Z-49
(2015)

CUMBERLAND AT BEECH HAVEN TRAIL
A Master Planned Residential Community

PROJECT TITLE
MASTER SITE PLAN

ZONING COMMENTS:

S1
SHEET

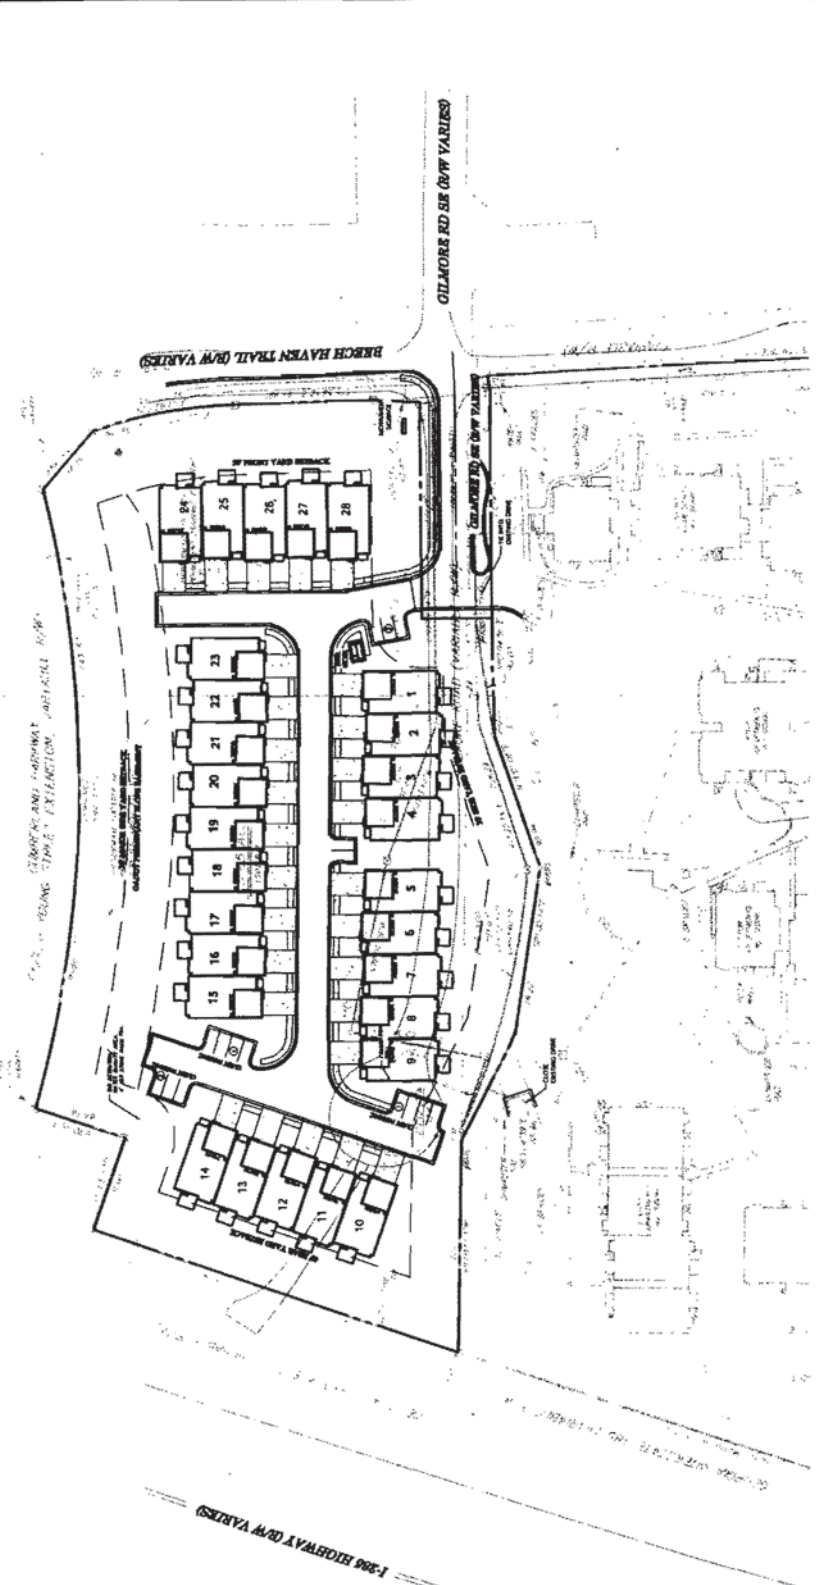
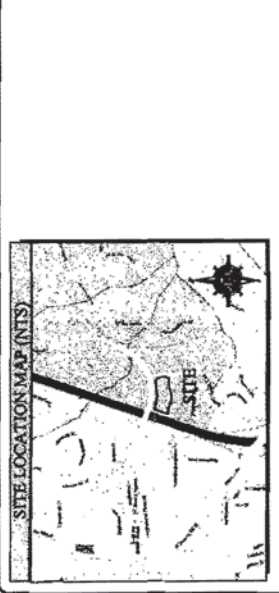
The site plan indicates the following contemporaneous variances will be needed:

1. Waive the front setback along Beech Haven Trail from the required 50 feet to 45 feet;
2. Waive the rear setback on the west side from the required 40 feet to 30 feet; and
3. Waive the side setback along the southern side from the required 35 feet to 20 feet.

These variances are needed if covered additions are added to the rear of these units.

- No Stormwater controls shown _____
- Copy of survey is not current – Additional comments may be forthcoming when current site conditions are exposed.
- No site improvements showing on exhibit.

1. This site is located at the southwest corner of Cumberland Parkway and Beech Haven Trail. It is also bounded by I-285 to the west and Gilmore Road to the south. The entire parcel drains to the northeast to an existing culvert under Cumberland Parkway. The existing site is wooded with moderate slopes except for the slope easement associated with Cumberland Parkway.
2. The site plan shows a bio-retention/water quality area near the northwest corner of the site. However, this area is not large enough to provide stormwater management the entire site and the majority of the site would naturally bypass this location. Additional stormwater management will be required. It may be possible to utilize the natural storage area within the slope easement at the northeast corner of the site, but this will likely take DOT approval.

Gilmore Road right-of-way will need to be abandoned prior to Land Disturbance Permit.

Recommend a deceleration lane on Beech Haven Trail for Gilmore Road.

Recommend sidewalk along the Gilmore Road frontage.

Recommend curb and gutter along both sides and sidewalk along one side of proposed development roadways.
